ENGINEERING PRACTICE STUDY

TITLE: PROPOSED CHANGES TO MIL-DTL-25677 AND ASSOCIATED SPECIFICATION SHEETS
REGARDING CAP AND NOZZLE FEMALE COUPLING END REQUIREMENTS

Project Number: 4730-2026-033

FIGURE 1. MIL-DTL-25667/3 Nozzle.

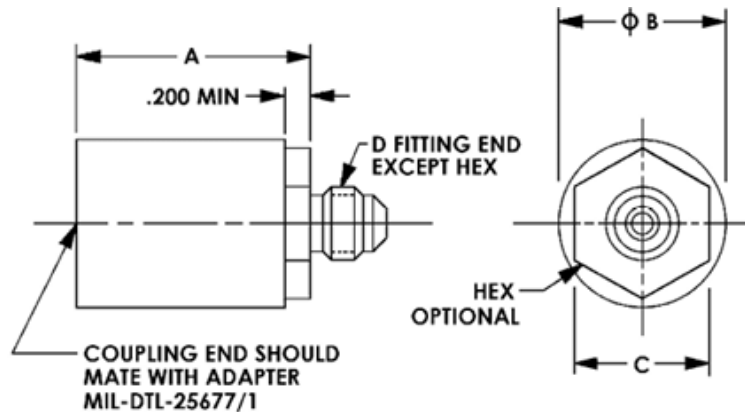
II. **BACKGROUND:** It was brought to DLA's attention that the lack of specific requirements for the female mating end components described in MIL-DTL-25677/2, /3, and /4, has been resulting in reduced interoperability. The mentioned specification sheets do not indicate any definitive requirements for the female coupling ends, stating "COUPLING END SHOULD MATE WITH ADAPTER MIL-DTL-25677/1".

Lockheed Martin: MIL-DTL-25677 spec should identify additional dimensions that will ensure that any MIL-DTL-25677/2, /3, or /4 made female QD from any vendor will correctly interface with any male QD MIL-DTL-25677/1 from any vendor. This should include a tolerance stack up analysis and detail specific dimensions, fitment tolerance, bearing size and placement. I think number of bearings may be less critical, but we have seen differences across manufacturers. We have seen firsthand that the lack of critical dimensions or tolerances on the female QD spec has resulted in some QDs not interfacing with the male side.

In total, we know of 13 Safran made female QDs and 1 HII made female QD that DO NOT Interface on Male QDs made by Crane. Two of the Safran female QDs checked good on a Safran Male QD but failed on a Crane Male QD. This illustrates the inconsistencies in a cross-vendor interface.

Visually, different manufactures of the female QD MIL-DTL-25677/3 are different, and a critical travel distance and center pin distance are absent.

Northrop Grumman: Specific requirements defining the interface between MIL-DTL-25667/1 and /3 are necessary to ensure compatibility between supplier's designs. Unfortunately, NGC does not have visibility on the possible variation that may exist across the suppliers' designs so we can't offer tolerances.

A project will be initiated to revise MIL-DTL-25677/3 to include more specific dimensional requirements, which should ensure improved interoperability between adapters and nozzles constructed by different manufacturers. Judging by the recommendations provided, the primary dimensions that needs to be specified are the minimum travel distance within the nozzle, and the center pin dimensions.

FIGURE 2. MIL-DTL-25667/1 Adapter with dimension "F" indicated.

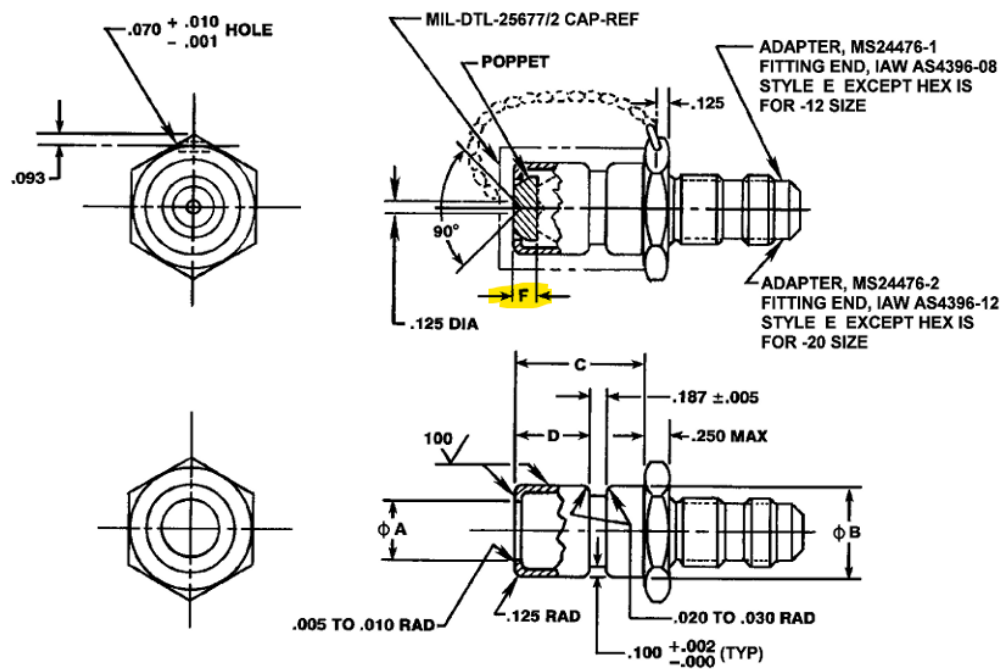
DLA was also requested to clarify what dimension "F" of MIL-DTL-25677/1 indicates. The specification is currently unclear as to whether dimension "F" indicates the desired poppet travel, or poppet thickness. Preliminary research found identical designs within the related International Standardization Agreement (ISA) STANAG 3595, which refers to ISO-9939 for design. ISO-9939 contains the same dimension "F", with the following note: "F is measured from the face of the connection and shows the OPEN position of the poppet". From this, it appears that dimension "F" indicates the poppet travel from the closed position to the open position.

- b. Is DLA's preliminary analysis of the intent behind dimension "F" of the MIL-DTL-25667/1 adapter accurate, and is it appropriate to incorporate the note from ISO-9939 into this specification?

Lockheed Martin: I agree with the clarification to dimension F and do believe it was intended to be the travel of the poppet head measured from the face of the male port. This is critical for the QD function.

Northrop Grumman: The illustrations in ISO 9939 help clarify the definition for the poppet travel. They would be helpful to include.

IV. CONCLUSIONS: A project will be initiated to revise MIL-DTL-25677/1 to clarify dimension F in a way similar to ISO-9939.
